Public Service Company of Colorado

March 30, 1984
Fort St. Vrain
Unit #1
P-84101

SUBJECT: NUREG-0737 Technical
Specification Changes
per Generic Letters
83-36 and 83-37

Figure 10.3-4 Schematic Flow Diagram: Cooling with Safe Shutdown Equipment

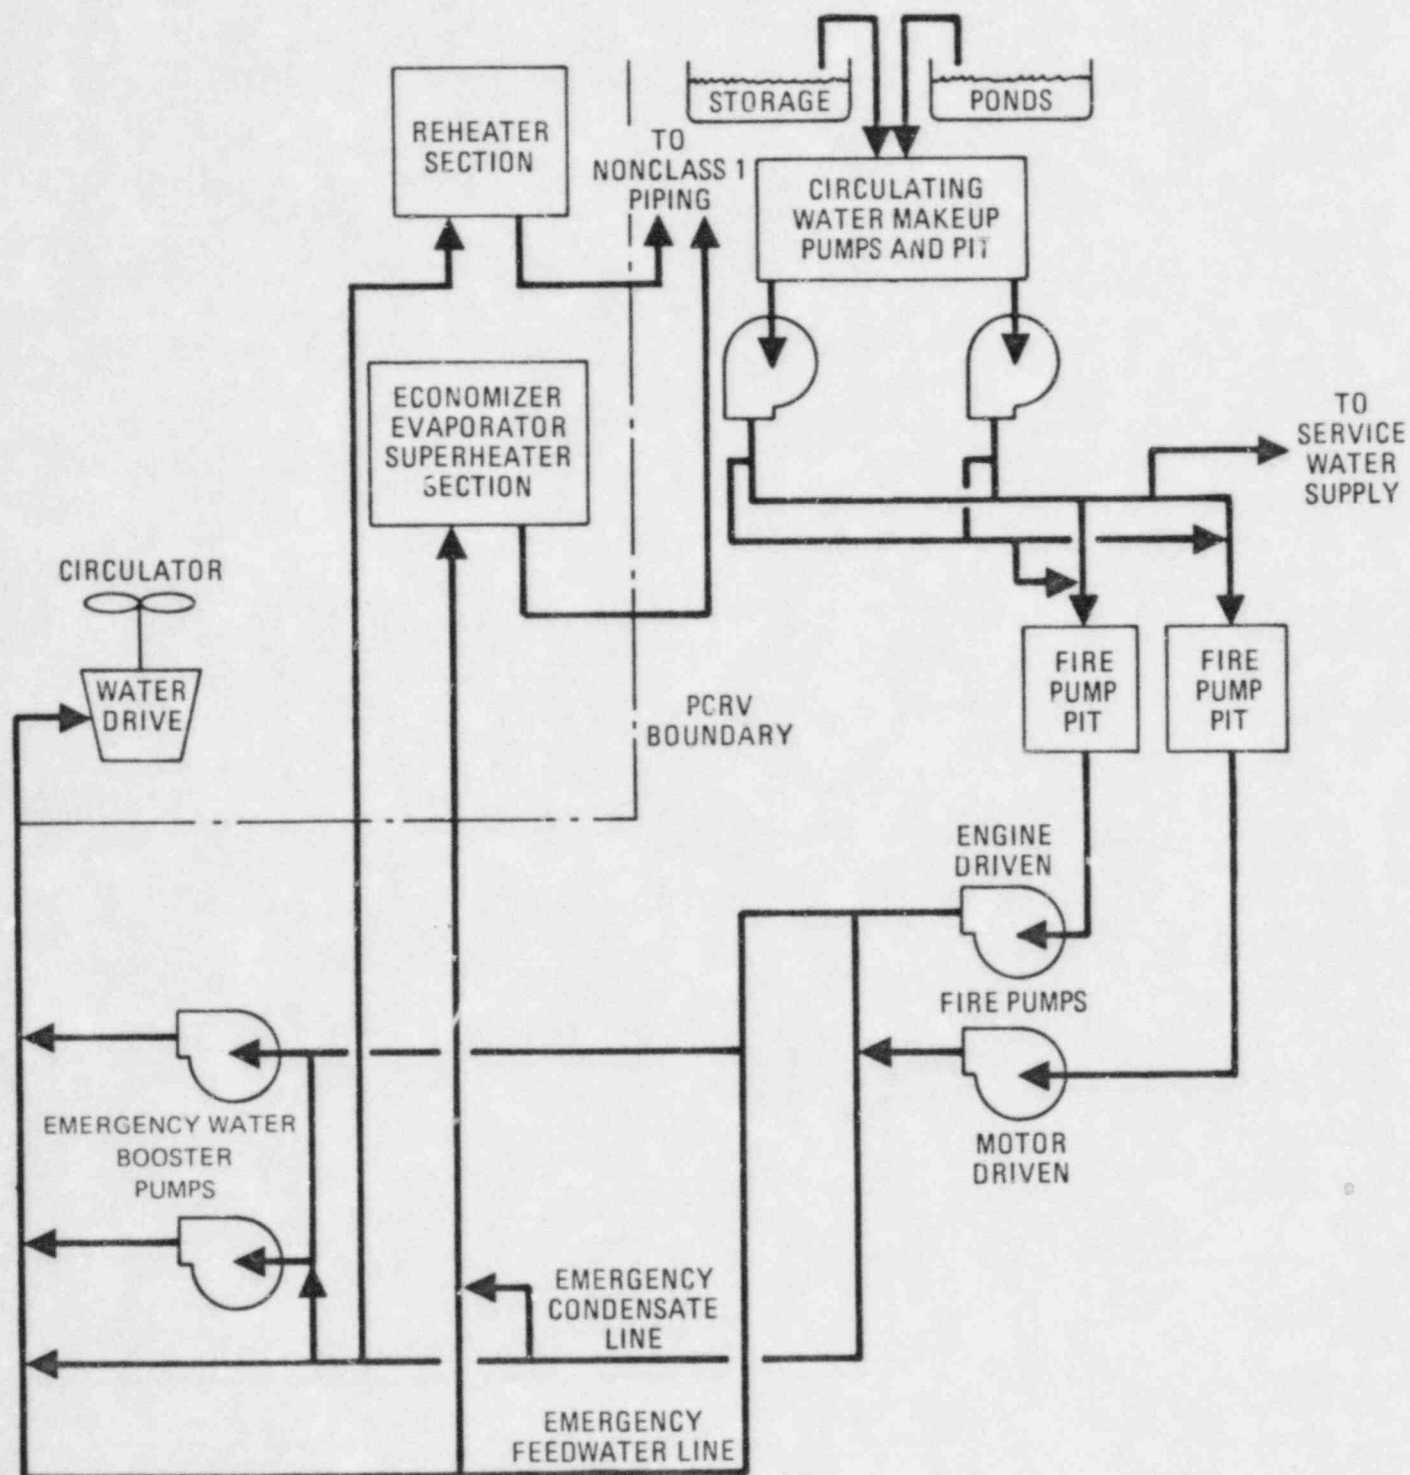
- II.E.1.1 The referenced LCO 4.3.4 does not adequately define the operability requirements nor are any surveillance requirements included to ensure this LCO is met. LCO 4.3.4 should be revised to specify operability conditions and the appropriate corrective action to be taken when those conditions are not met. In addition, appropriate surveillance testing requirements should be included in the FSV TS which demonstrate header operability including proper circulator operation when powered from each header.

In order to address the concerns expressed in G-84080, March 8, 1980, relative to the operability of safe shutdown cooling equipment (see attached Figure 10.3-4 from the FSV FSAR) the following summary of LCO's and Surveillances is provided:

- Storage Ponds - LCO 4.3.5 states that the reactor shall not be operated at power unless the inventory of the circulating water makeup storage ponds is at least 20 million gallons. SR 5.2.24 a) requires the circulating water makeup pond minimum inventory to be verified daily and the pond level instrumentation be functionally tested monthly and calibrated annually.

- Circulating Water Makeup Pumps and Pit - LCO 4.2.5 requires at least two circulating water makeup pumps connectible to the essential bus shall be operable during power operation. SR 5.2.25 b) states that the circulating water makeup pumps shall be functionally tested weekly. The pump controls and instrumentation including the fire water pits shall be functionally tested monthly and calibrated annually.

- Fire Pump Pits and Fire Water Pumps - LCO 4.2.6 states that the reactor shall not be operated at power unless the fire water system (including both fire water pump pits and both the motor and engine driven fire pumps) are operable. SR 5.2.24 b) requires the functional testing of the fire water pump pits monthly. SR 5.2.10 requires both the motor driven and engine driven fire pumps to be functionally tested monthly and calibrated annually.

- Fire Water Booster Pumps - LCO 4.2.19 requires that there be one operable fire water booster pump during power operation. SR 5.2.23 requires that each fire water booster pump be tested annually by providing motive power to one helium circulator water turbine drive in conjunction with the performance of SR 5.2.7 (see Helium Circulators, below).
- Helium Circulators - LCO 4.2.1 requires that at least one circulator be operable in each loop during power operation. LCO 4.2.2 defines circulator operability as follows:
 - a) Emergency Feedwater and Fire Water are available to drive the water turbine and the capability for turbine water drainage exists. The Emergency Feedwater or Condensate Header may be inoperable for up to 24 hours without the helium circulators being considered inoperable.

- Bearing Water System - Operability of the normal bearing water system is specified in LCO 4.2.2 as part of the requirements to establish helium circulator operability. Current surveillance requirement SR 5.2.8 requires that both the normal and emergency bearing water makeup pump be operated in the recycle mode every three months. The associated instruments and controls are functionally tested in conjunction with these tests and calibrated annually. Proposed revision to SR 5.2.8 (P-83416) will require, if accepted, that each bearing water pump and its associated instruments and controls be functionally tested at each scheduled shutdown. Additionally, it will require an annual calibration of the bearing water pump instruments.

- Service Water Pumps - LCO 4.2.4 requires that at least two service water pumps and the associated pump pit be operable during power operation to ensure the capability of supplying essential components with cooling water. Proposed revision to surveillance requirement SR 5.2.24 (P-83416) will require, if accepted, that each service water pump and its associated instruments be functionally tested monthly. Additionally, the instruments shall be calibrated annually, and the pump performance and mechanical condition verified annually.

- Instrument Air - LCO 4.3.6 requires that at least two instrument air compressors, their associated air receivers, and two main air headers to the reactor building and turbine building be operable during power operation to ensure air supply to essential instrumentation required for safe shutdown cooling. Surveillance requirement SR 5.3.6 requires that the pressure indicators and low pressure alarms on the instrument air receiver tanks and headers be functionally tested monthly and calibrated annually.

- Safe Shutdown Cooling Valves - Surveillance requirement SR 5.3.4 requires that those valves that are pneumatically, hydraulically, or electrically operated which are required for actuation of the Safe Shutdown Cooling mode of operation be tested annually. In addition, this test shall include the normally closed check valves which are required to open for actuation of the safe shutdown cooling mode of operation. Additionally, proposed revisions to SR 5.3.4 (P-83416) will require, if accepted, that valves which must be manually positioned for actuation of the safe shutdown cooling mode of operation be tested annually.
